Thor Motor Coach Technical Service Bulletin

TSB #	TSB 22-09		
Description/Title:	Rize/Scope A/C install		
Affected Product Line(s):	Certain model year 2022 – 2023 Rize & Scope		
Service Campaign # :	RC000272	Released Date:	
Codes:	Inspect with Repair: TMCTS80249W	Document Date:	7/5/2022
Time Allowed:	Inspect with Repair: 4.0/hrs	Document Revision:	A

Rize/Scope A/C not installed correctly.

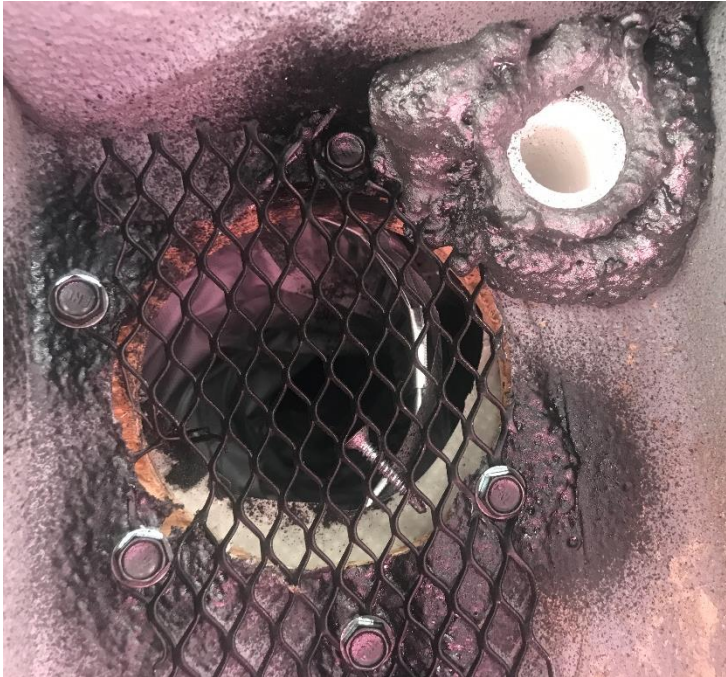
3. Seal needs to be added around the opening between the intake plenum & van body.

4. A/C exhaust plenum #16 on the TIP0425 print is not lined up with the air exhaust opening. The screws need to be removed and the plenum slide rearward.
